# Townhomes

# **Stucco Detailing** north & south buildings

# materials north and south buildings

TYPICAL BAY AT SOUTH BAR, NW PETTYGROVE STREET

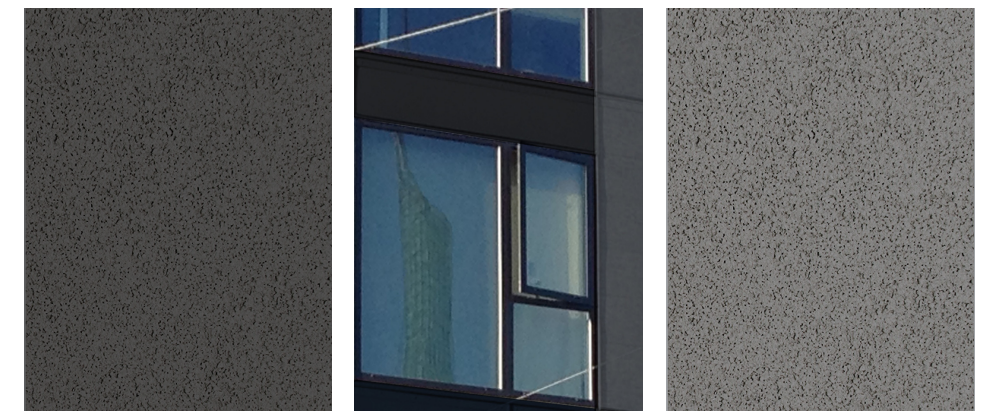
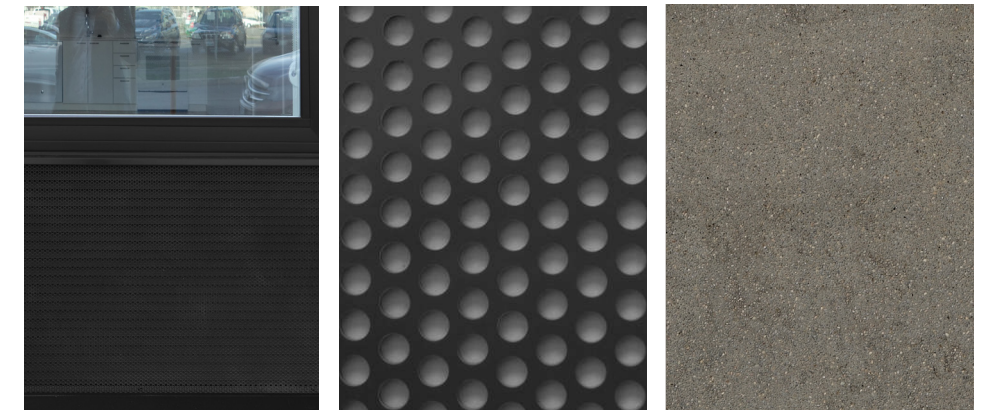
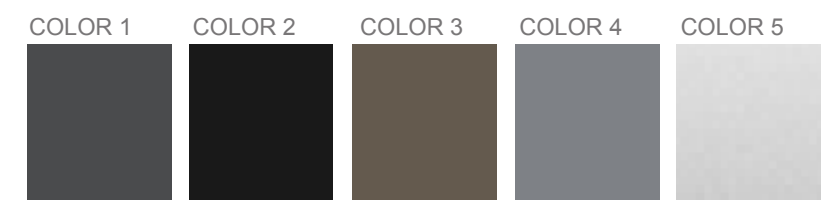
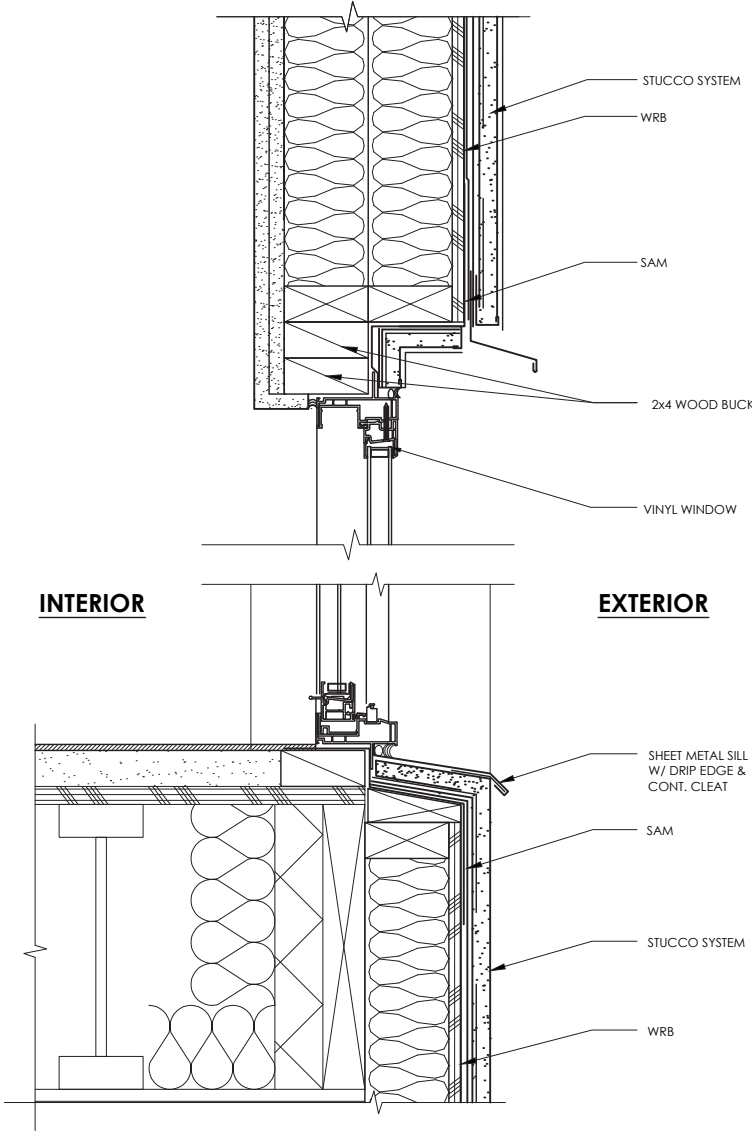
**DR 01 recommendation: all stucco in the same plane should be the same color**

**DR 01 recommendation: recess windows in the north & south bar at least 4" (glazing to face of exterior wall)**

**DR 01 recommendation: consider fewer control joints**

**Response: color changes in same plane eliminated**

**Response: windows and spandrel panels recessed 4"**

**Response: control joints simplified**

# Entry Plaza

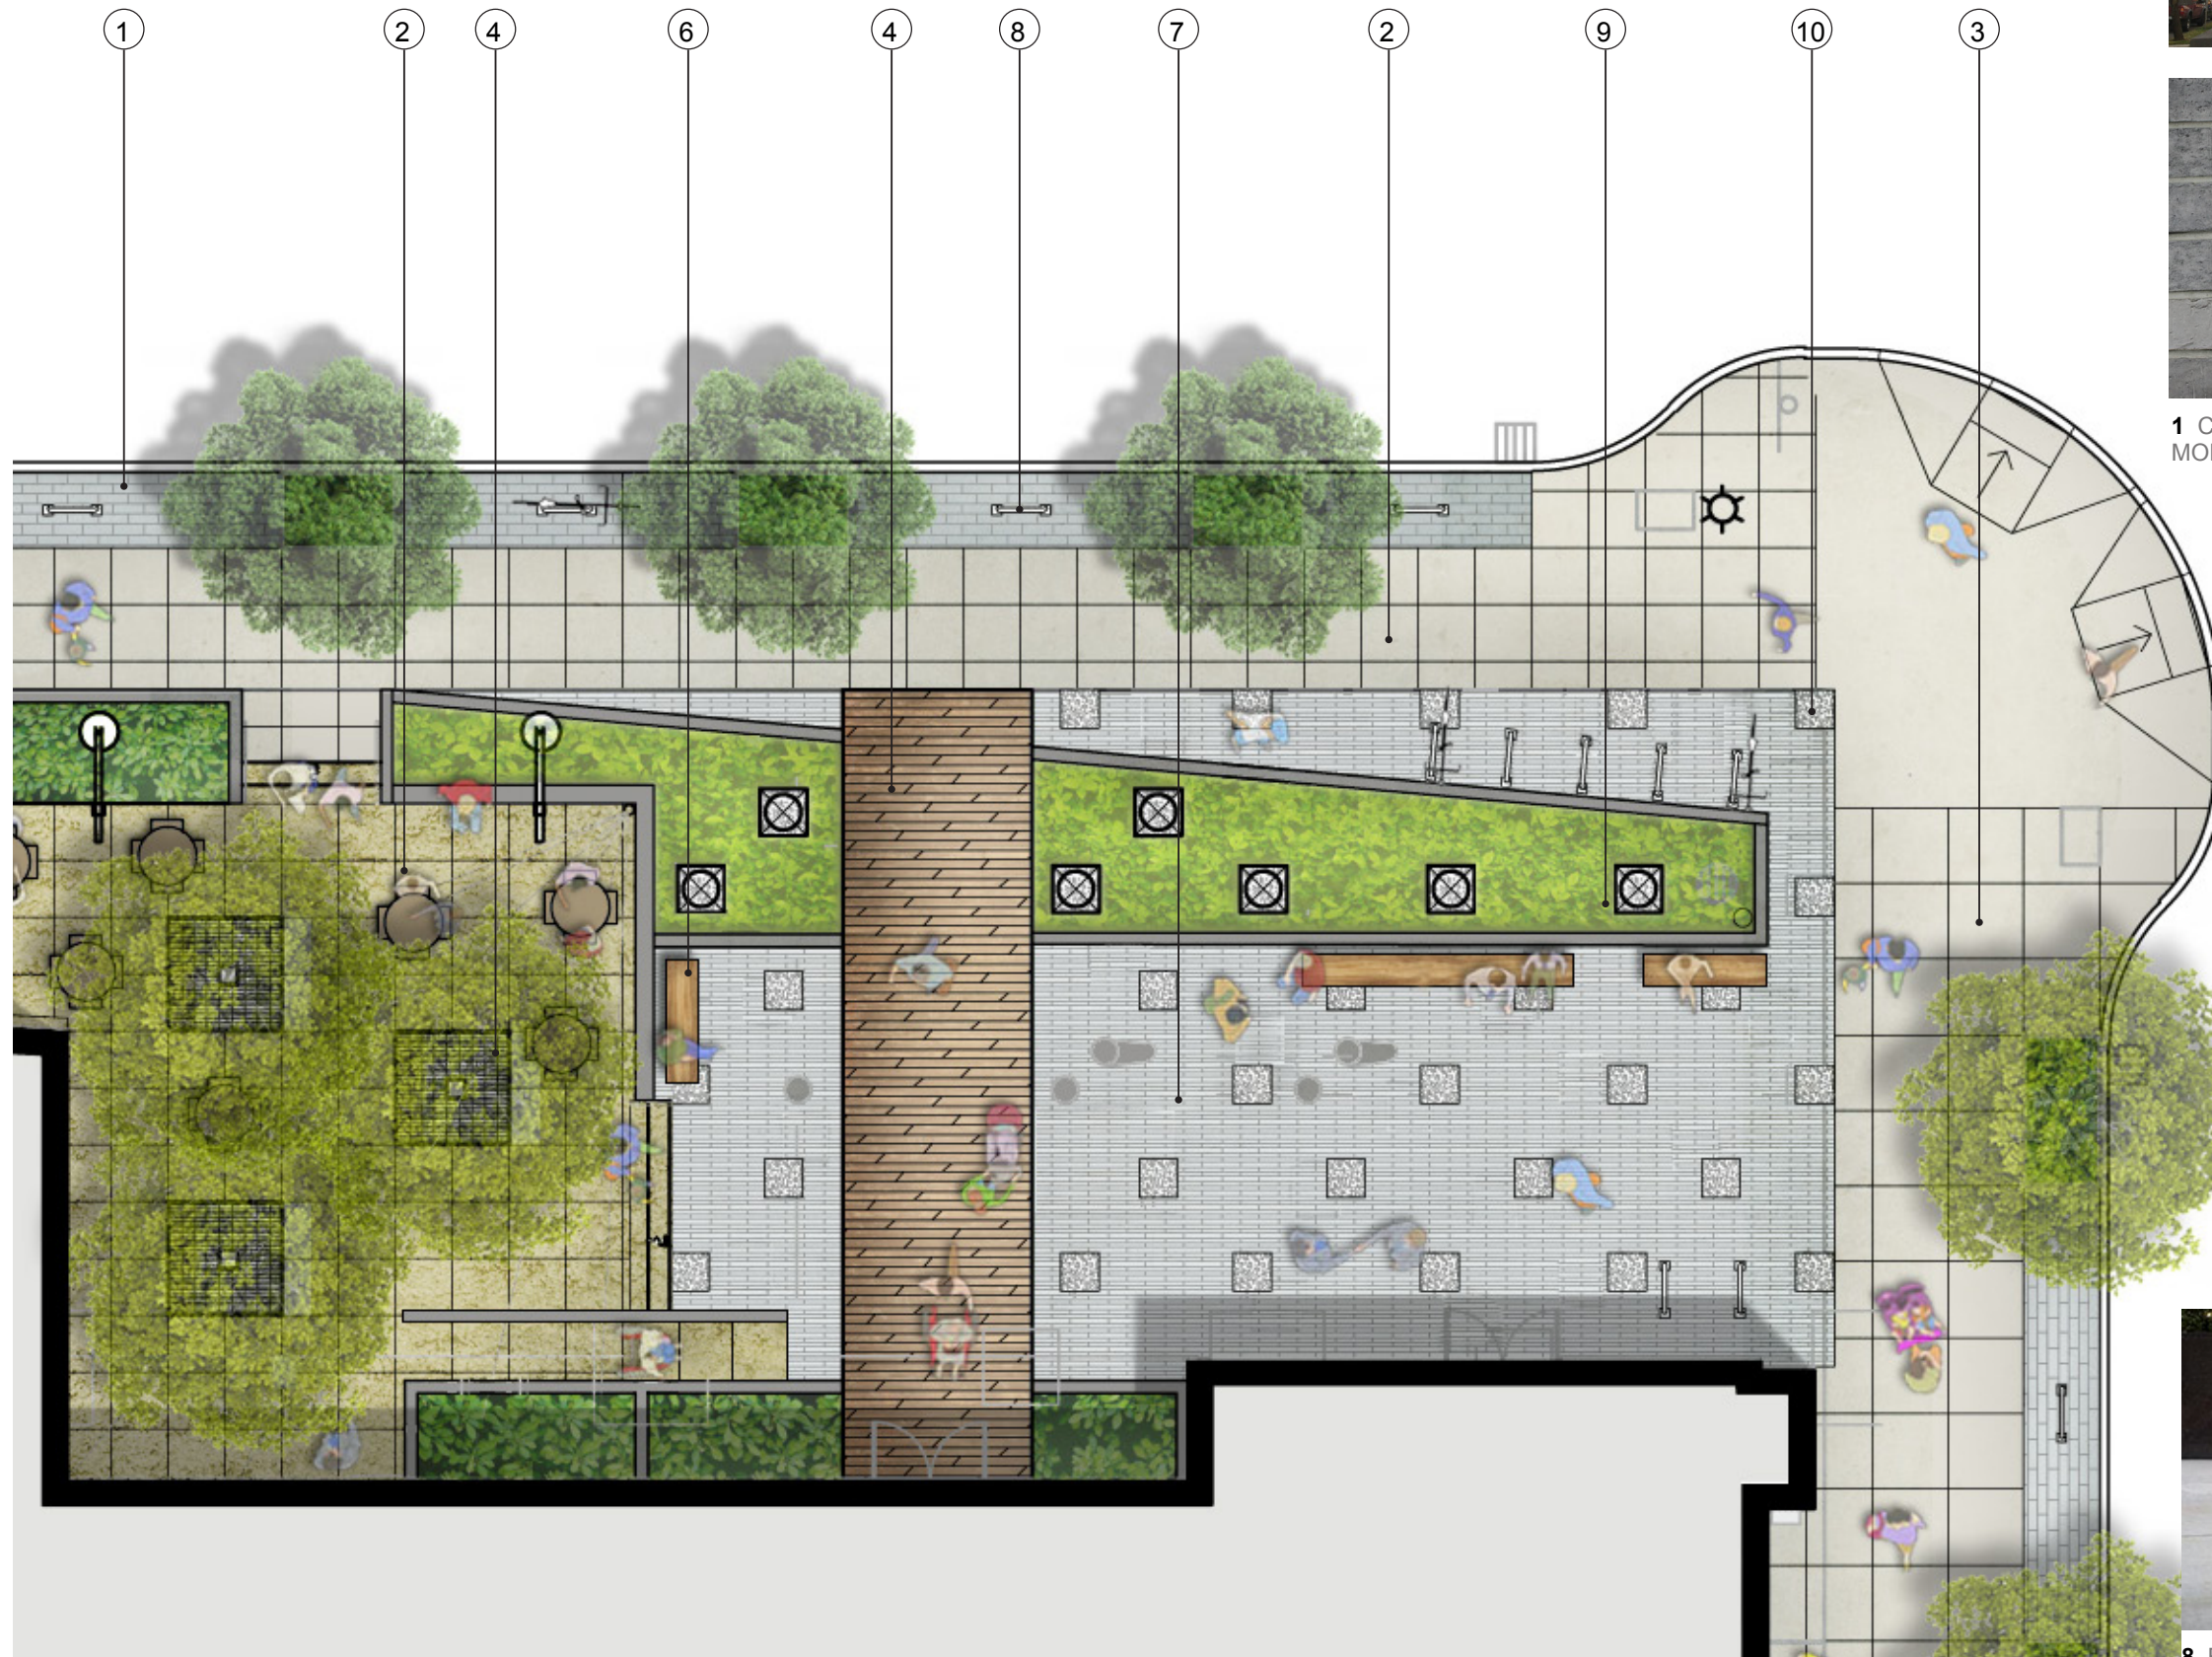
DR 01 recommendation: consider re-ordering tilt-up accent blocks

**Response: accent block layout given more order**

# ground floor window analysis

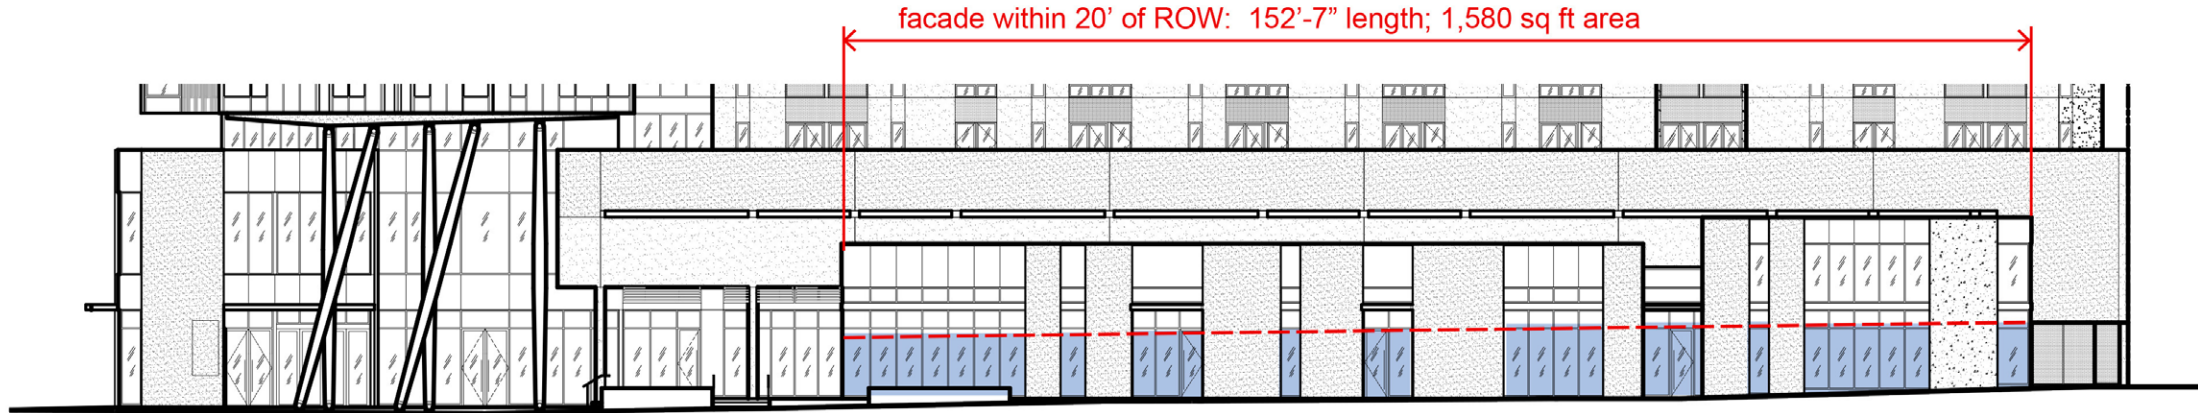
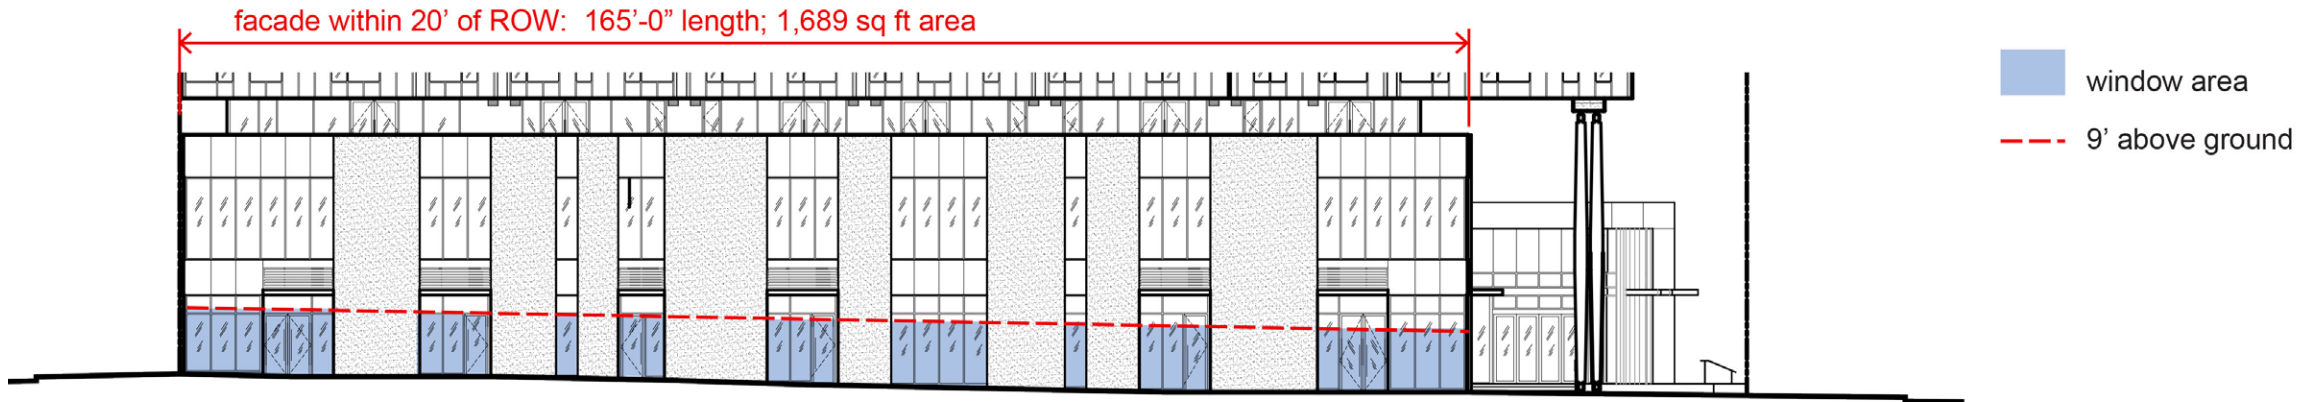
The percentage of glazing length and area along NW Pettygrove is below the minimum required by 33.140.230 B. when the residential frontage is excluded. See Modification 5 in design narrative.
